Addendum 1

Project: Mound Fort Jr High School HVAC Replacement Project
Contract Documents Dated: February 2023
Addendum No: 1
Pages: 4

Drawing M404 (Attached)

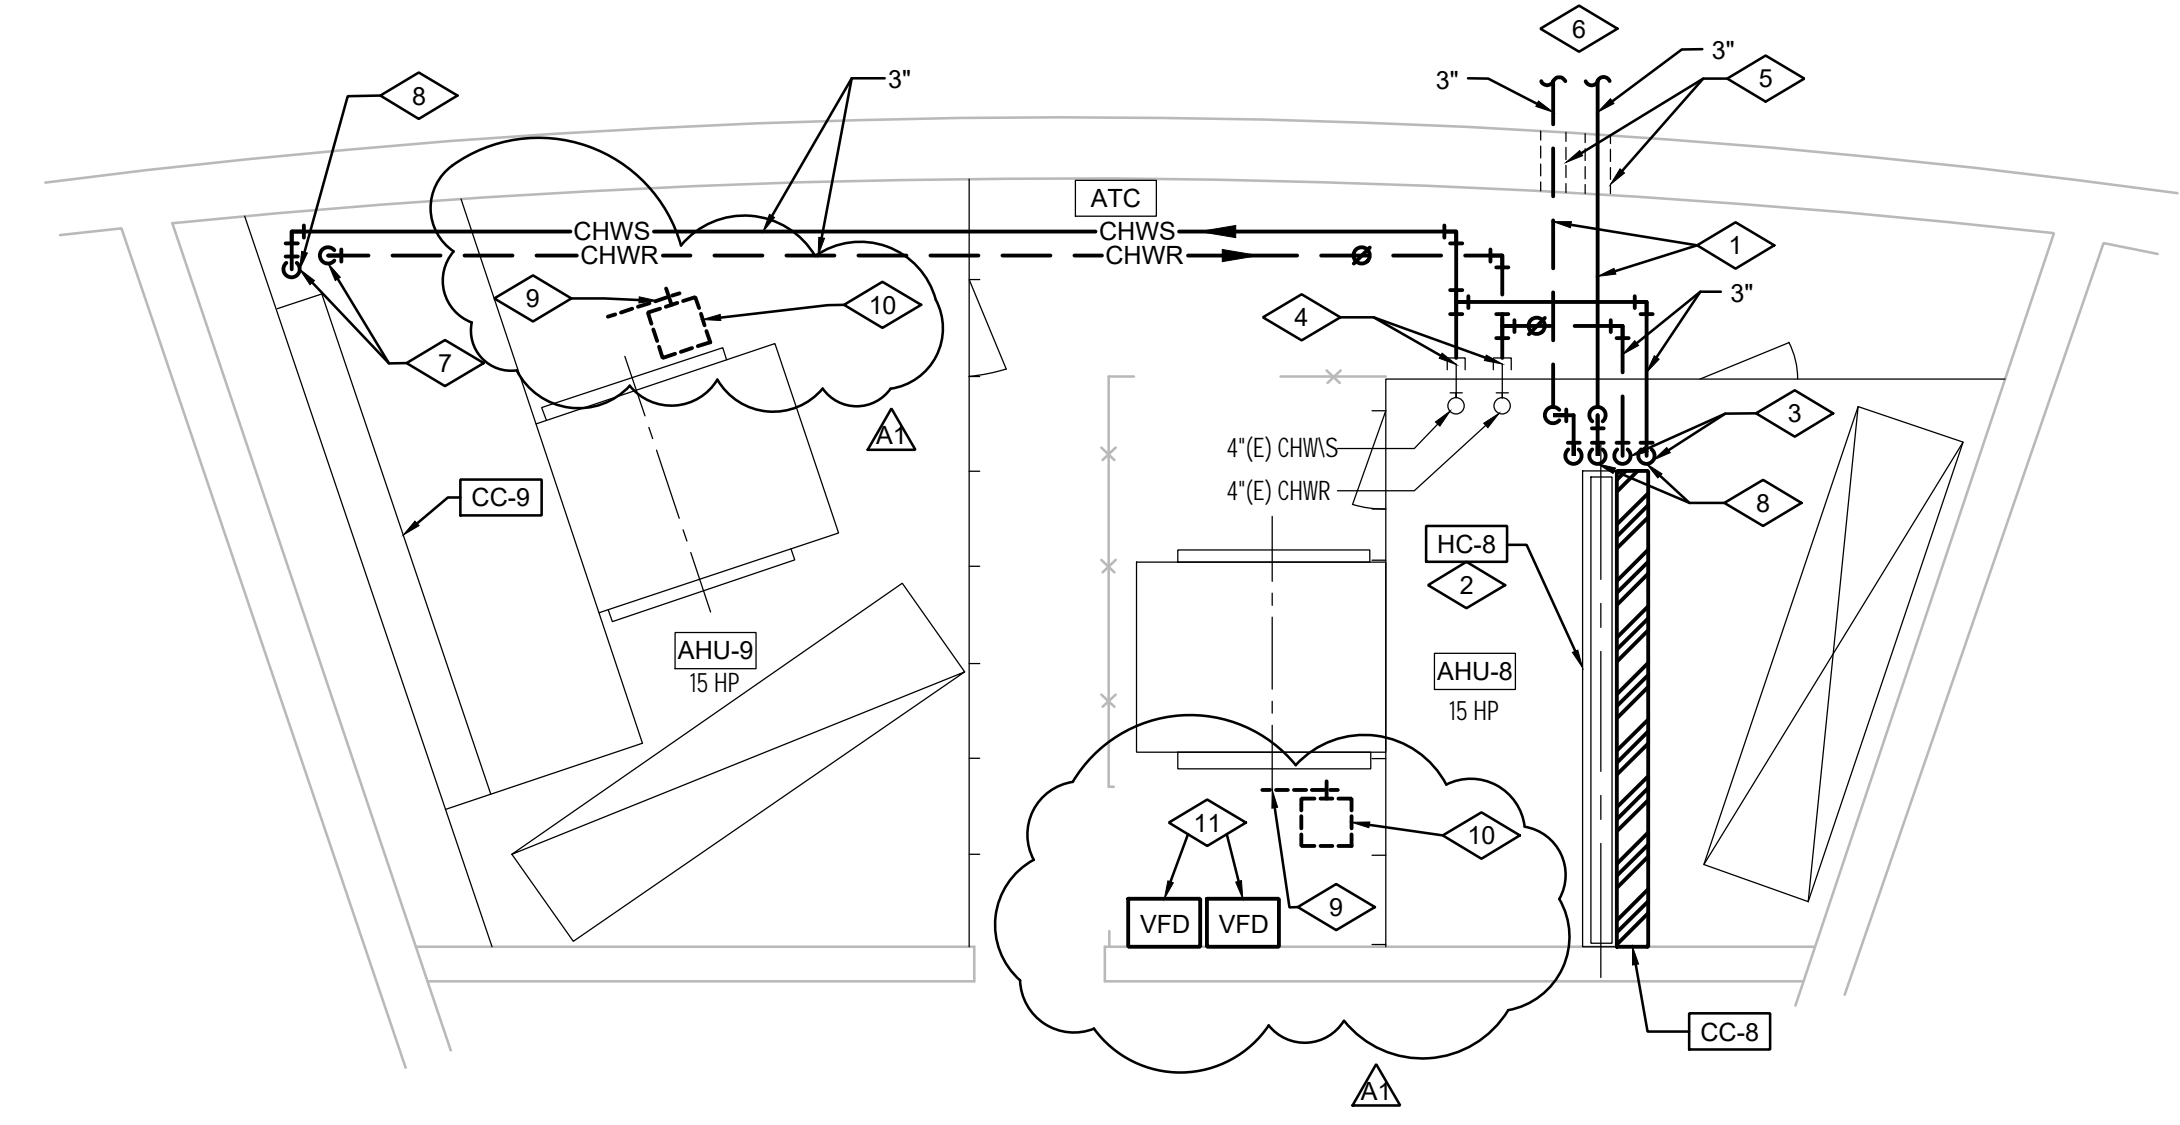
Replace the existing fan motors serving AHU-8 and AHU-9 with new VFD compatible motors (15 HP) each and new fan belts.

Provide new VFD's for the new 15 HP fan motors.

Added Note 9, 10 and 11 to Keyed Notes

- 8 PROVIDE 3-WAY COIL CONTROL VALVES WITH BYPASS FOR EACH COOLING COIL AND HEATING HOT WATER COIL CONNECTION. SEE DETAIL 511663
- 9 INSTALL NEW FAN MOTOR BELTS. FAN BELTS TO BE SAME SIZE AND TYPE AS EXISTING.

- 10 INSTALL NEW SYNCHRONOUS 15 HP FAN MOTOR MATCHED WITH NEW VFD.
- 11 INSTALL FAN VFD'S ON WALL IN THIS LOCATION. CONNECT NEW FAN MOTORS TO NEW VFD. INTERLINK CONTROLS TO NEW DDC CONTROL SYSTEM.
